From: Mitman, Jeffrey
Sent: Wednesday, October 20, 2010 2:43 PM
To: Ferrante, Fernando
Subject: FW: OUO/SRI-FW: Information Related to an NRC External Flood Inspection Issue at Oconee
Attachments: [Redacted] ^{Outside of Scope} Wilson Independent Review HDR Comments.pdf; Wilson Independent Review.pdf; Young Independent Reivew HDR Comments.pdf; Young Independent Review.pdf

REVIEW OF THE HDR ENGINEERING, INC. TWO-DIMENSIONAL SIMULATION OF FLOW IN THE VICINITY OF OCONEE NUCLEAR STATION RESULTING FROM A HYPOTHETICAL DAM FAILURE SCENARIO AT LAKE JOCASSEE.

Subject: **Independent Technical Review**
HEC-RAS and SRH-2D Hydraulic Modeling
Wilson Engineering Project WE10009

Addressing Review Comments from Independent Review

FIGURE 1 - CROSS SECTION PLACEMENT DOWNSTREAM FROM KEOWEE DAM

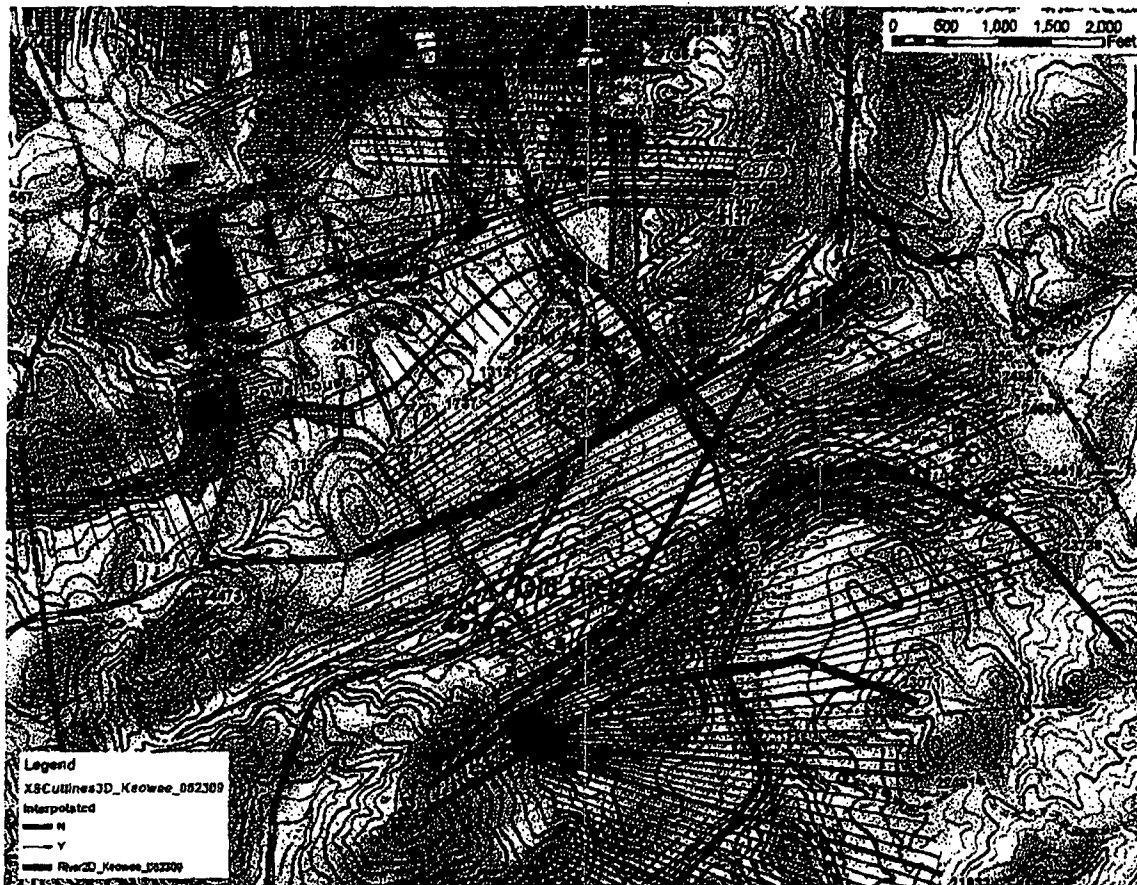
HEC-GeoRAS was used to acquire cross sections from a DTM and specified cut lines. This approach allowed a great deal of geometric information to be represented in the HEC-RAS model. Spot-checking of the cross section alignments revealed a few areas where cross section alignment should be reconsidered. Figure 1 illustrates one such location downstream from Keowee Dam: the cross sections were located in the vicinity of "Big Bend" assuming that the saddle between Old Pickens and Big Bend would be overtopped and during the peak event would act as the main channel. Although this may be true, the normal flow channel would be better represented using the four cross sections overlaid as thick red lines.

The selection of Manning's n roughness coefficients was generally reasonable, however the assignment of the coefficients in some places was incorrect. For example, in the reach which comprised Keowee Lake, cross section n values were assigned based on bank station placement, and in some places the banks were set too far from the normal pool lake extents, thus causing areas that are currently heavily wooded to be assigned too low n values. Similarly, n values in the vicinity of Big Bend (Figure 1) were inappropriate.

FIGURE 2 - MIXED FLOW EXPONENT COMPARISON, KEOWEE RIVER - UPSTREAM OF EASTATOE RIVER

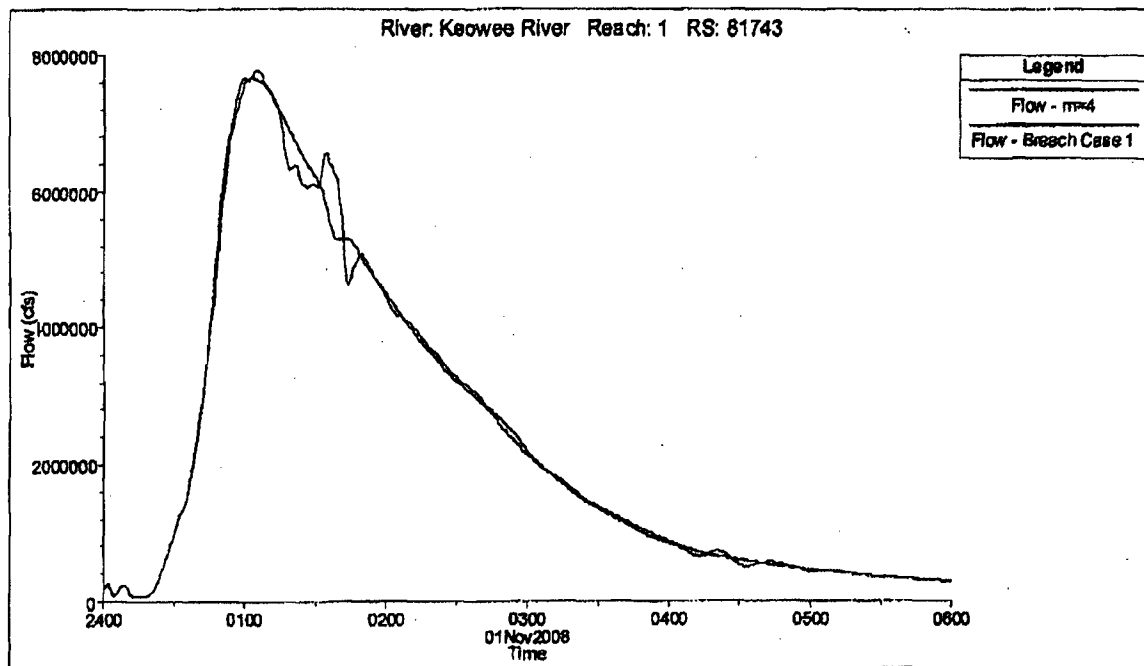
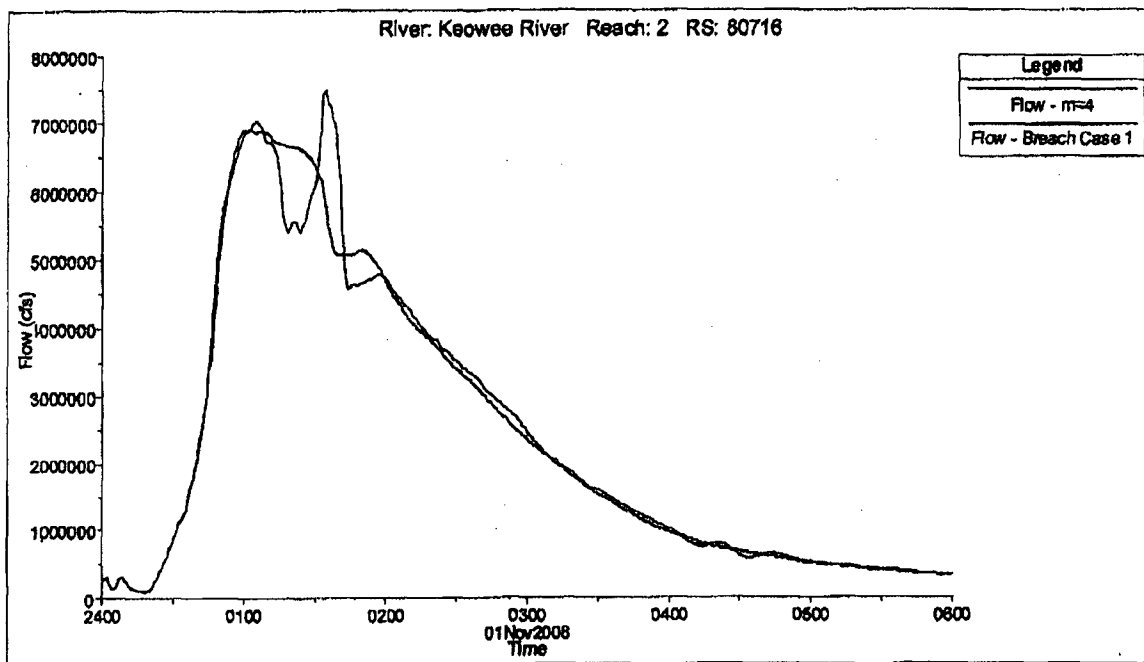
I changed the mixed flow exponent, m, from the default value of 10 to 4 to determine the impact on the occurrence of non-convergence errors, average error, and predicted peak elevations. All "solver went unstable" messages were eliminated and the errors associated with the "iterations exceeded" messages and predicted water surface elevations were significantly reduced:

Reduction of this factor decreased the numerical error in the solution and caused a substantial dampening of the predicted peak elevations. An examination of two hydrographs illustrates that the results from the analysis using m=4 produces more realistic, monotonic hydrographs. Both hydrographs are taken from a typical HEC-RAS model run which experienced numerical oscillations on the Keowee River (Breach Case 1), just upstream and downstream from the confluence with the Eastatoe River, are shown in Figure 2 and Figure 3.

Based on this analysis, use of the non-default mixed flow exponent yields more reasonable results, and should be used in future.

FIGURE 6 - BREACH FORMATION STEP FUNCTION

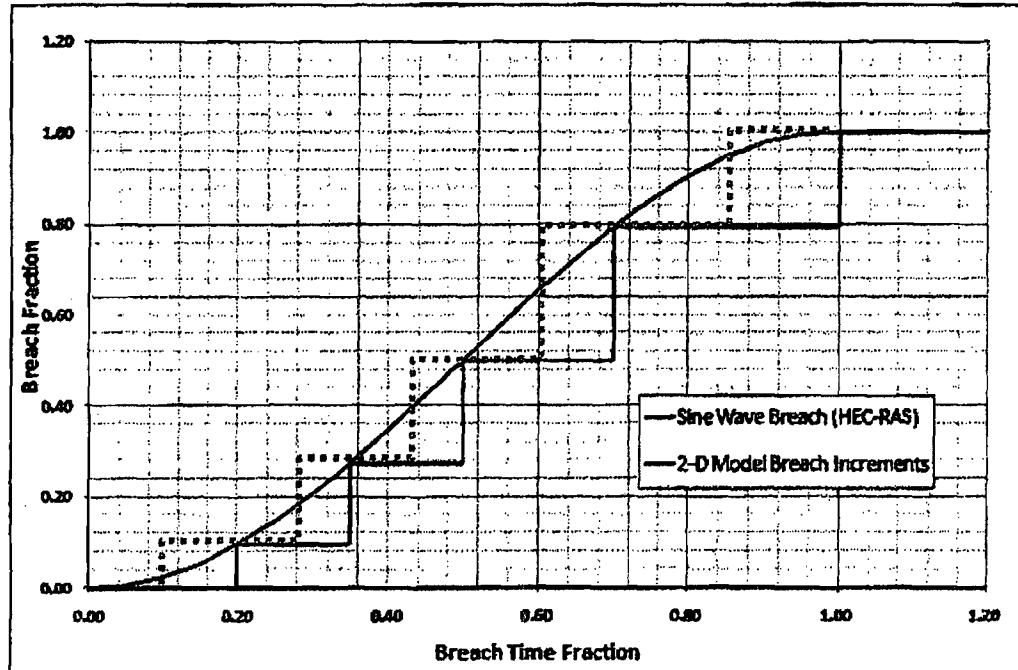
Section 3.4 of the SRH-2D report described how the breaches had to be simulated using the 2-D model: the sine wave breach formation was approximated using a 6-part step function by stopping the model at a specific time, adjusting the mesh to represent the partial breach, and restarting the simulation. As shown in Figure 8 of that report, the timing of these manual steps lagged the HEC-RAS sine-curve function. In my opinion, a better approach would have been to have the steps straddle the sine curve, as indicated in Figure 6 as a green dotted line. This would have enabled a slightly more faithful representation of the HEC-RAS breach formation, shifting it about 10% of the total breach formation time (in the case of Keowee, about 15 minutes). The impact of this time shift was not determined, but it is not expected to be large, relatively speaking.

The fine mesh and short time step caused a single SRH-2D model run time to exceed several days, taking it to the edge of practicality. If additional 2-D modeling is to be performed, I recommend that Duke Energy consider funding some additional software development so HDR can enhance the SRH-2D code to add a breach formation algorithm. Not only would it allow the 2-D model to better match the HEC-RAS breach formation results, but it is likely that a smooth adjustment of the mesh would introduce less shock to the numerical algorithm compared to the step function. This would allow the model to be run using a larger time step and allow the simulations to be done in less time. Another possible avenue to decrease overall runtimes would be to implement parallel processing features in the code to enable it to utilize multiple cores and processors.
